Title of Change:	Information of different brightness surface of Ni/Cu in DBC due to different shape of copper grain in raw copper material of DBC		
Effective date:	04 Jan 2022		
Contact information:	Contact your local onsemi Sales Office or Noriaki.Sakamoto@onsemi.com		
Type of notification:	This Product Bulletin is for notification purposes only. onsemi will proceed with implementation of this change upon publication of this Product Bulletin.		
Change Category:	Assembly Change, Package form (cosmetic) difference point		
Change Sub-Category(s):	To be sure brightness difference of Ni/Cu surface in DBC is good product		
Sites Affected:			
onsemi Sites		External Foundry/Subcon Sites	
onsemi Vietnam		None	
Description and Purpose:			
The purpose of this PB is to advise customers of a cosmetic difference in brightness that could be observed due to different copper grain shape of the raw copper material of DBC. This brightness difference is within surface roughness spec and there is no quality impact. This is a cosmetic difference only.

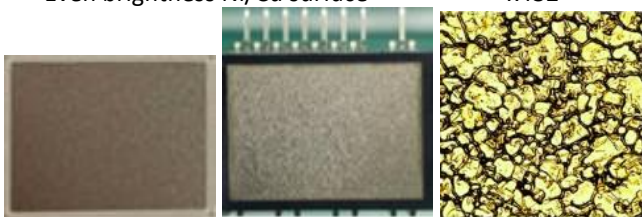
Two different brightness surfaces are following.			
Even brightness Ni/Cu surface  Uneven brightness Ni/Cu surface 			
Reliability Data Summary:			
Reliability is no impacted.			
Electrical Characteristics Summary:			
Electrical characteristics are not impacted.			
List of Affected Standard Parts:			
Note: Only the standard (off the shelf) part numbers are listed in the parts list. Any custom parts affected by this PCN are shown in the customer specific PCN addendum in the PCN email notification, or on the <u>PCN Customized Portal</u> .			
NFAQ0560R43T	NFAQ1560R43TL	NFAQ1560R43T	
NFAQ0860L36T	NFAQ0860L33T	NFAQ1060L36T	
NFAQ1060L33T
